Wednesday, August 7, 2013 City Council Chambers

**7:10 PM COMMUNITY CONFERENCE: Issaquah Middle School,
Application PLN COM13-00002**

CITY OF ISSAQUAH
Development Commission - Minutes

PUBLIC HEARING: Issaquah Plaza 221

mahlum

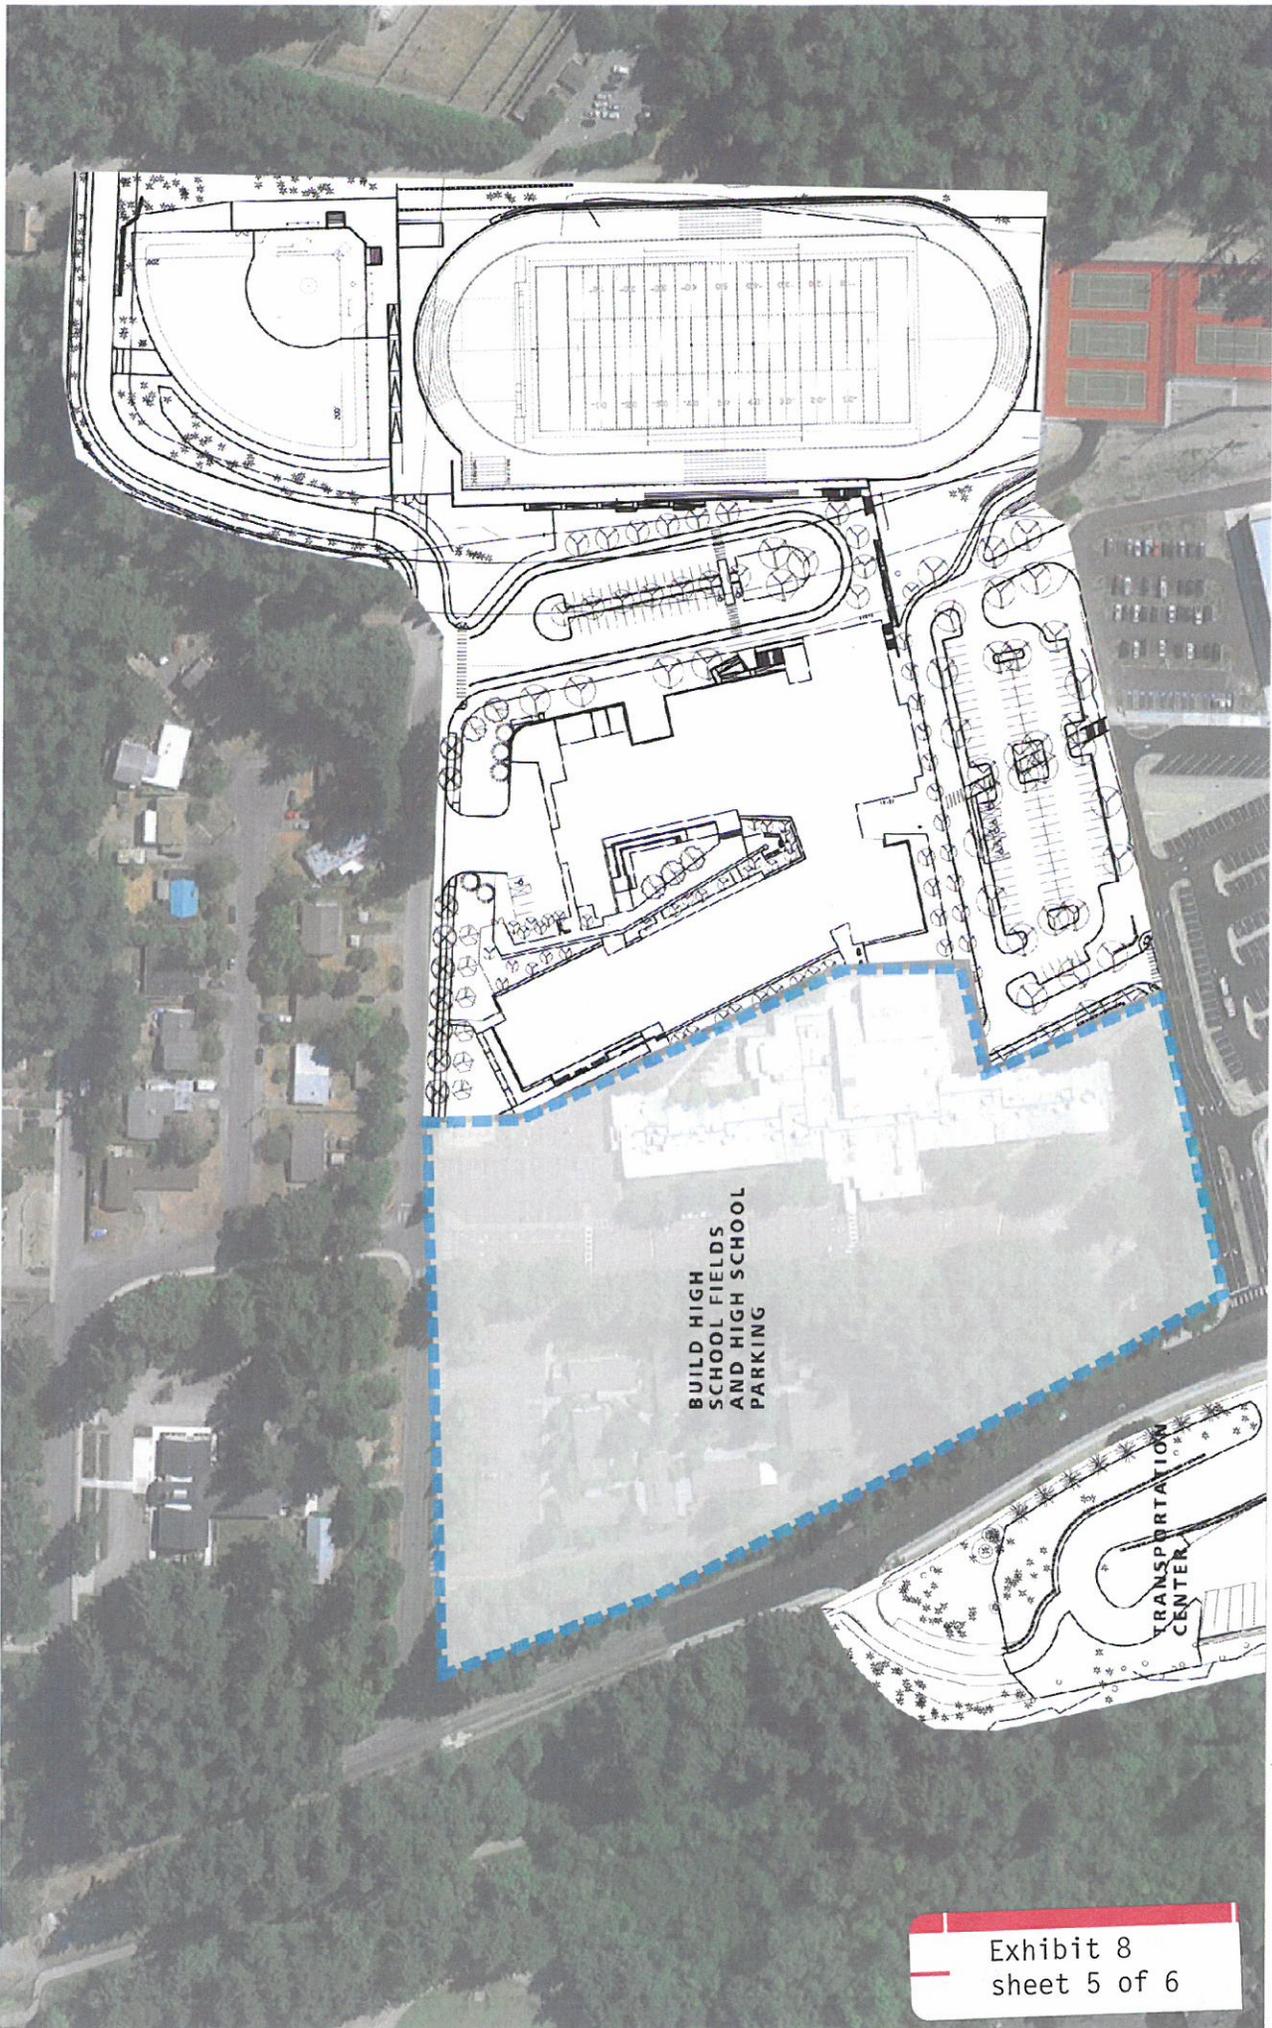
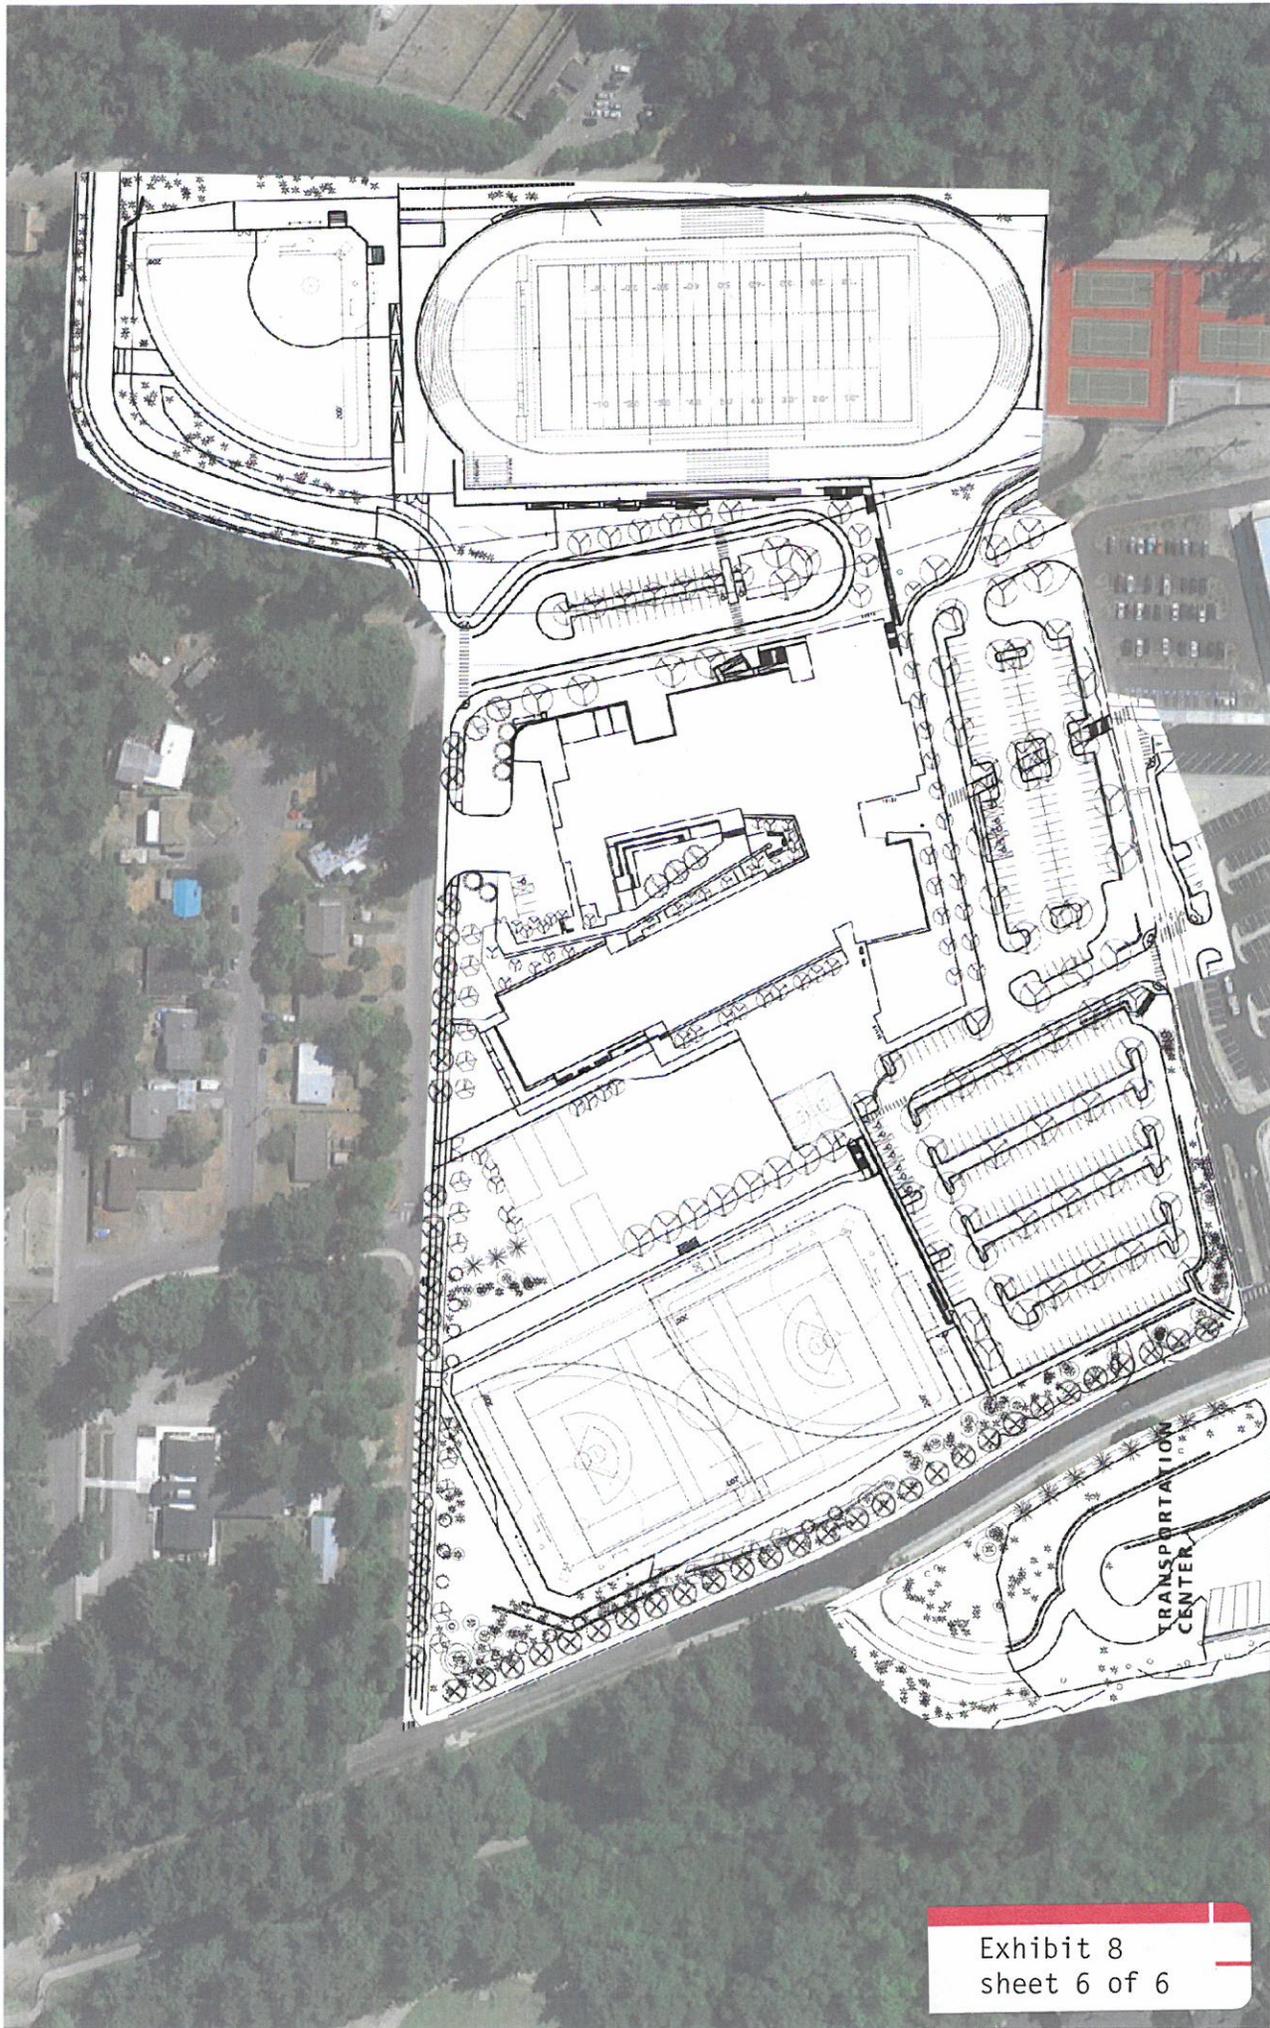
Aerial photos with the project development imposed on those aerials illustrate the phasing of the Middle School project (6 sheets show phasing with Exhibit 8). The entire project will take a few years to complete with different areas of the large site being affected at different times with regards to demolition, staging and construction. The narrative states that the school project will occur in 3 phases as follows:

With submittal of the Master Site Plan application, the School District will need to submit a detailed plan for the phasing and staging of the entire project. Of special interest will be how the school proposes to address parking for the adjacent high school students
